STATE OF MICHIGAN
DEPARTMENT OF NATURAL RESOURCES
LANSING

August 23, 2012

Re: Fisheries comments concerning DEQ file no. 12-81-0027-P

Longitudinal Profile

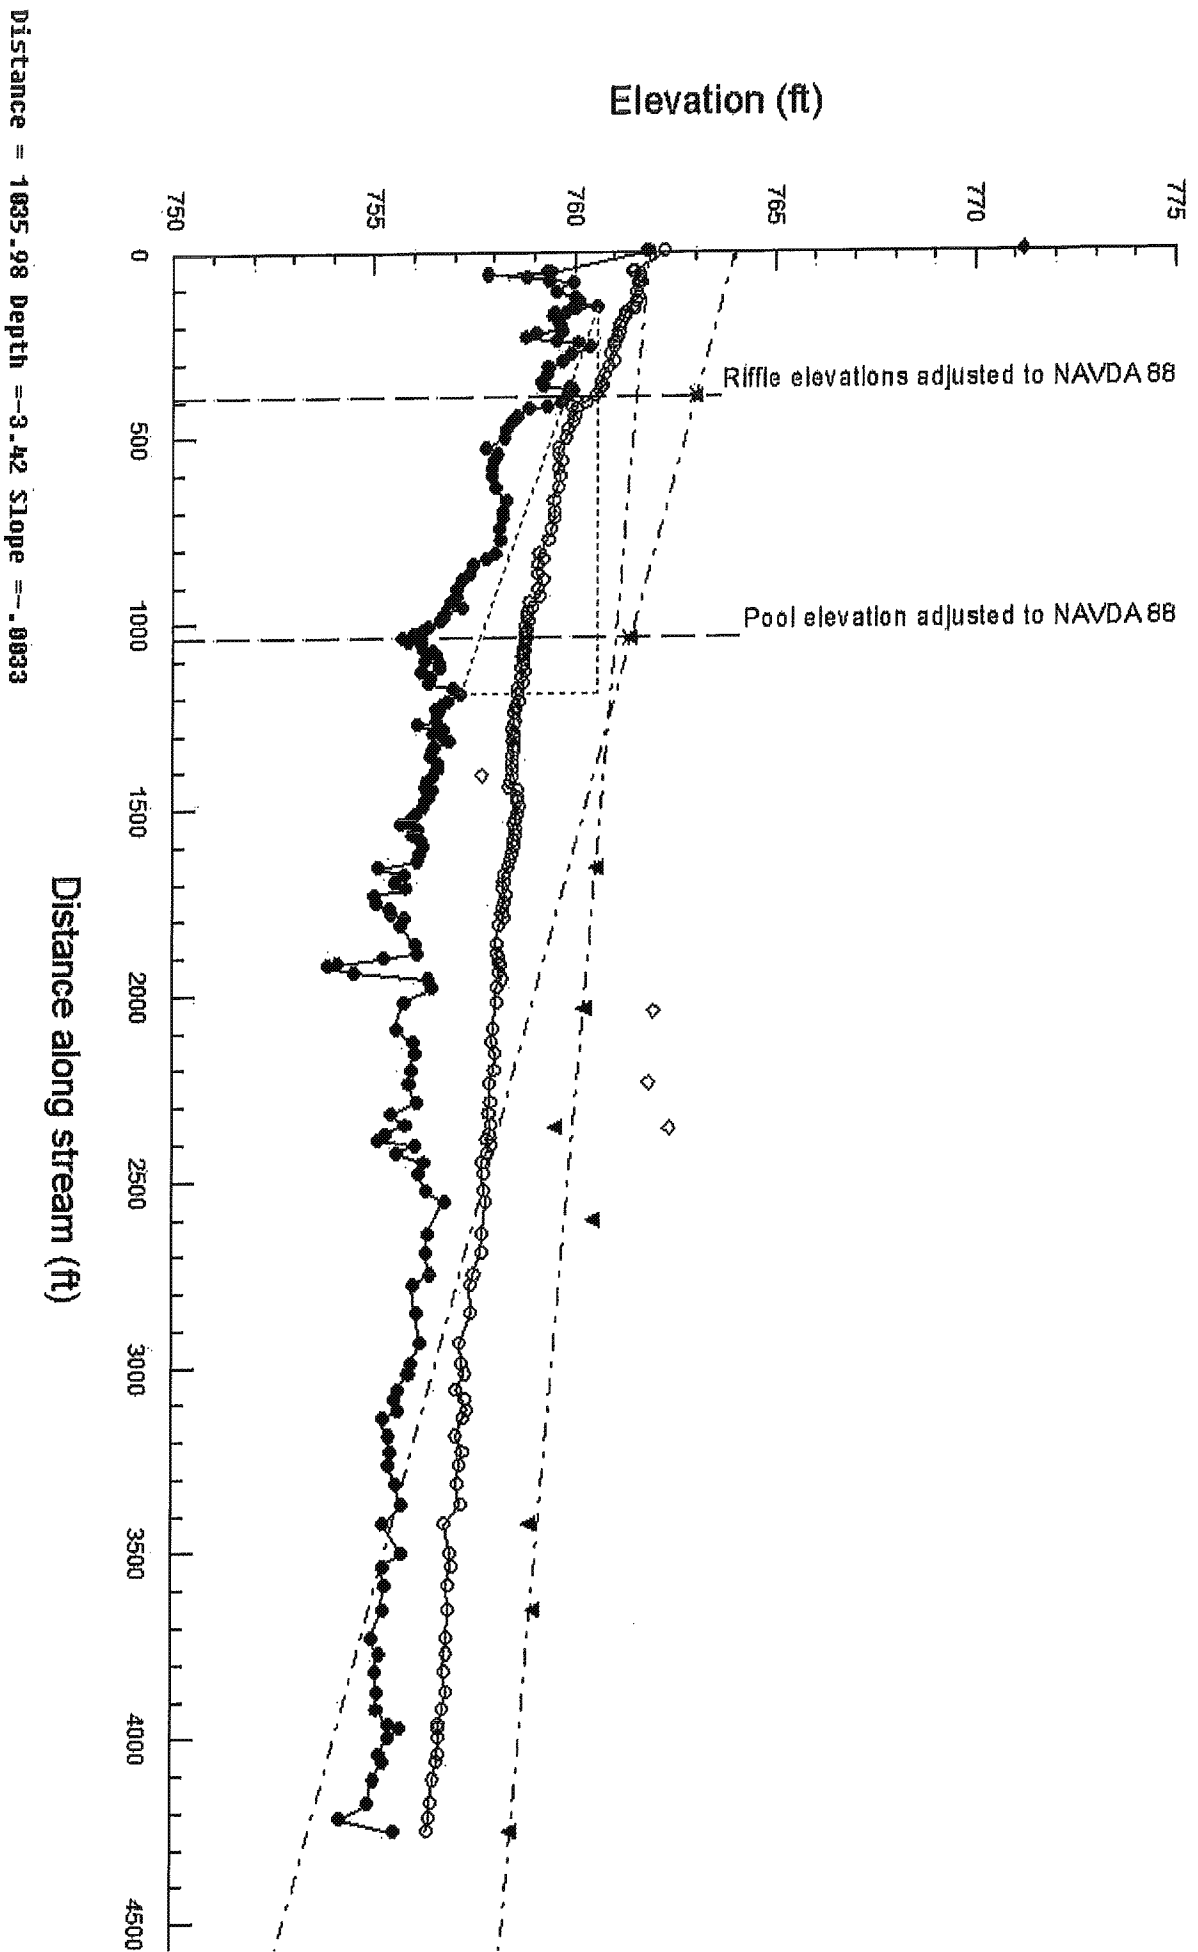
Clearly, based on the information provided by the applicant and analysis conducted by DNR, the proposed structures will change the character of the stream from a riffle/pool sequence stream to that of a step/pool system. The proposal modifies the existing stream into a channel type that

is not stable based on the natural slope of the valley. Although overall slope of the channel may remain the same as it is currently, facet to facet slope changes, thereby inducing channel changes in flow, bedform and planform.

USGS 04174500 HURON RIVER AT ANN ARBOR, MI

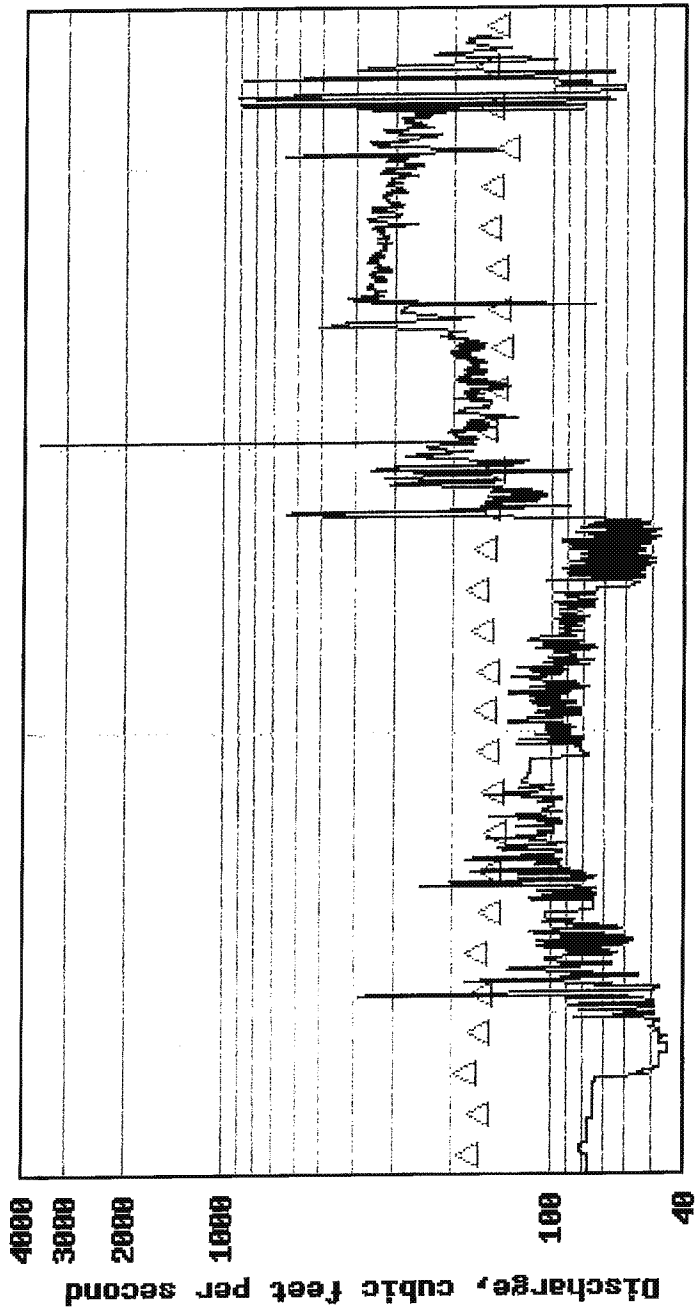
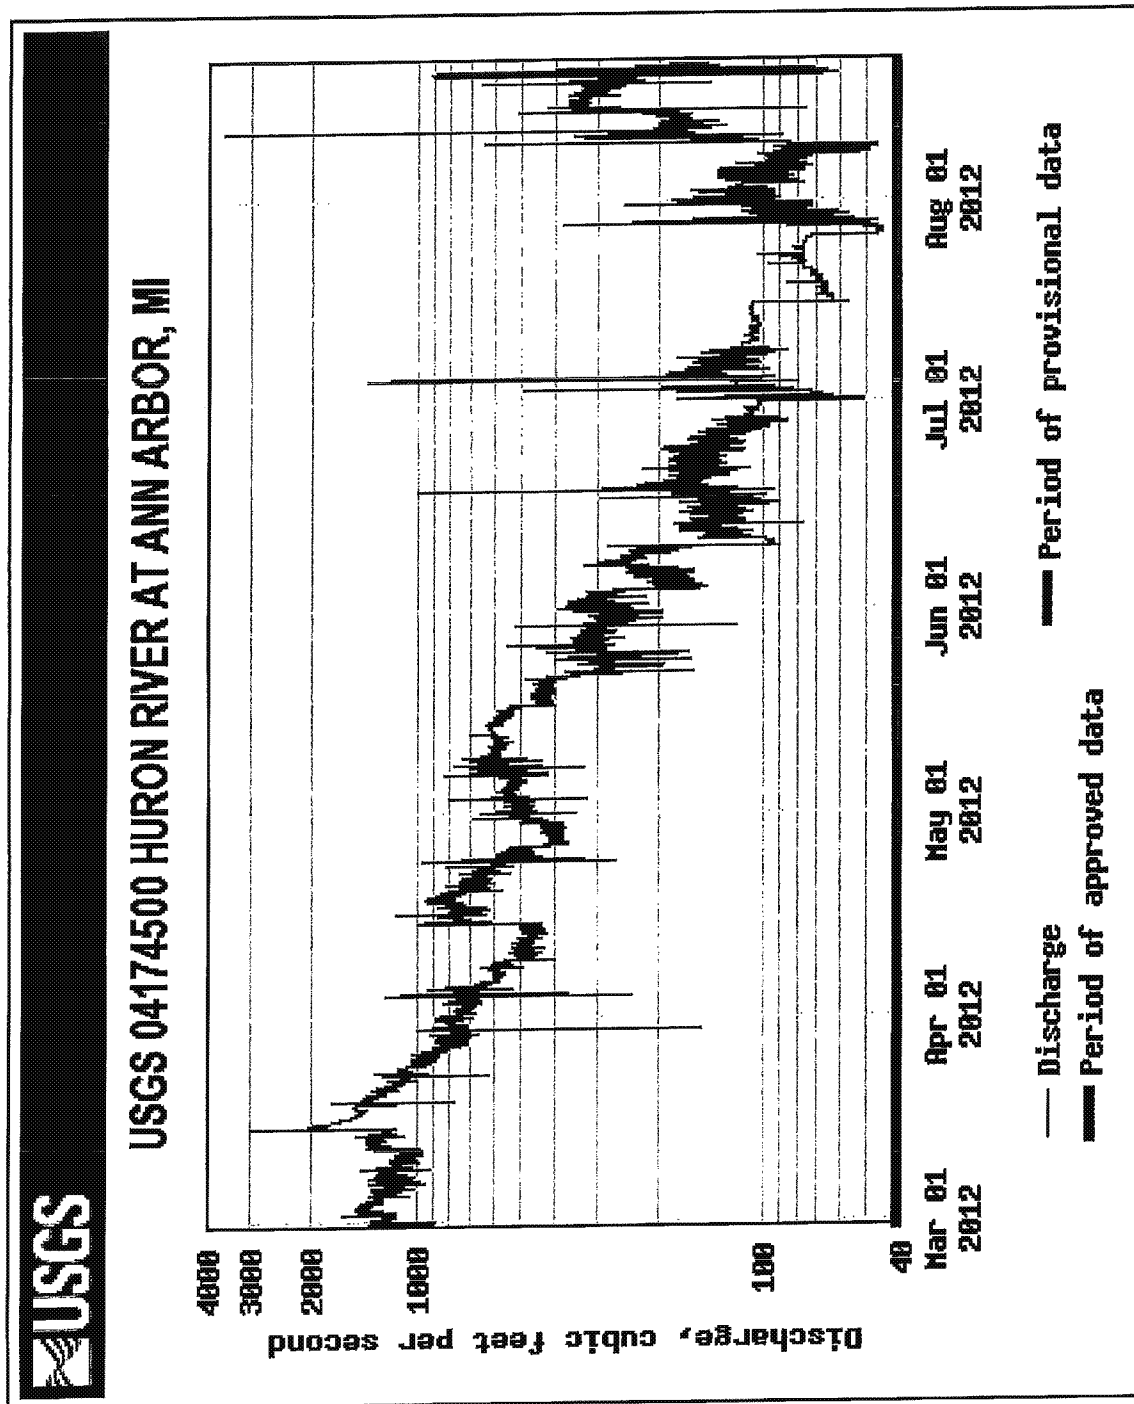
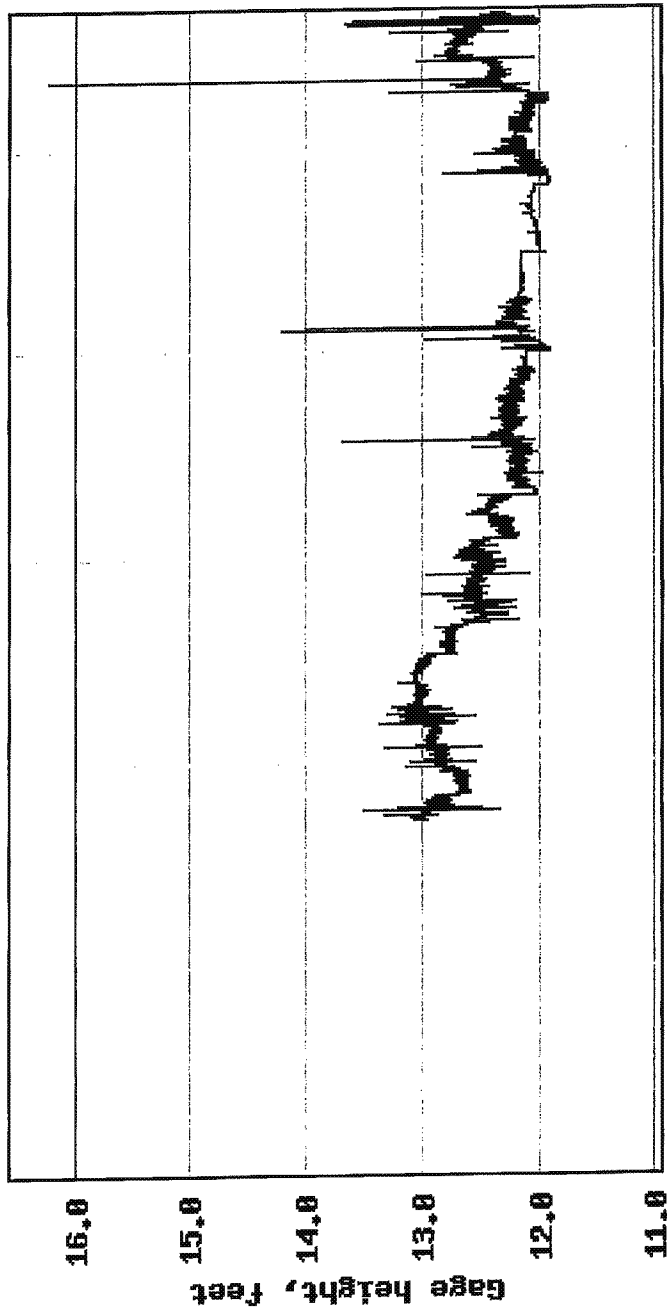
In the same letter, DNR addresses issues with erratic flow issues that have been measured and documented at the USGS Wall Street Gage which is located downstream of the Argo Dam and the proposed structures. DNR has been working with the City of Ann Arbor and the Federal Energy Regulatory Commission (FERC) to identify and address the erratic and inconsistent flows (i.e. large fluctuations and saw tooth hydrograph) that are recorded at the gauging station. The origination of the source or sources of the erratic flows is important as stage may increase well over a foot with a resulting change in discharge of hundreds or thousands of cfs in a matter of minutes (Attachment 8).

Specifically, the letter outlined concerns which included the un-natural flow hydrograph as recorded at the USGS Wall Street Gage and a recommendation for minimum flows. The City of Ann Arbor responded later in the week that they would not adopt the DNR's minimum flow recommendation and planned to continue to operate as they have. The fact that no operational plan was ever developed has resulted in controversy and potential resource damages to the state's public trust resources.

Longitudinal Profile

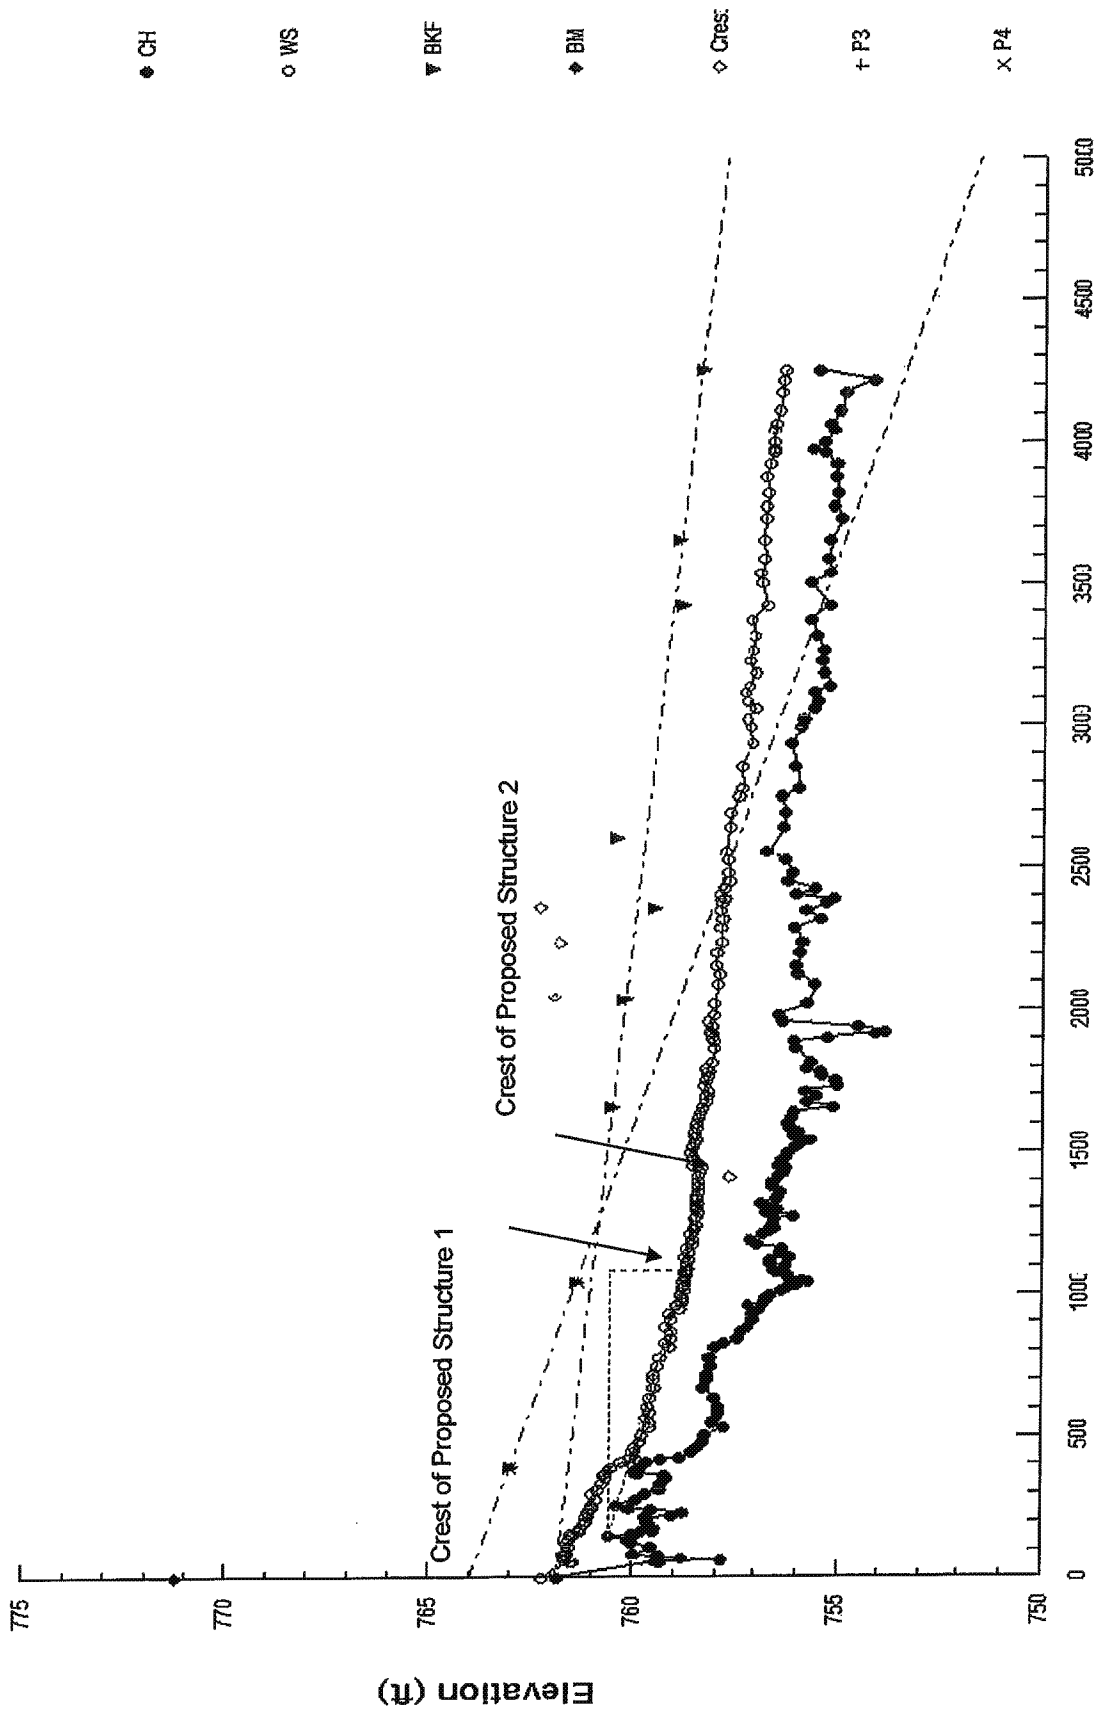
According to the plans provided by the applicant, the maximum fill in elevation at structure 1 is 6.6 ft and 5.9 ft at structure 2 and raises the invert of the bed elevation. These constitute major changes to bedform, slope, roughness and cross-sectional area and the stream will adjust. These changes will not allow the stream to remain dynamically stable thereby maintaining its current dimension, pattern and profile and continue to transport stream flows and sediment without aggrading or degrading.
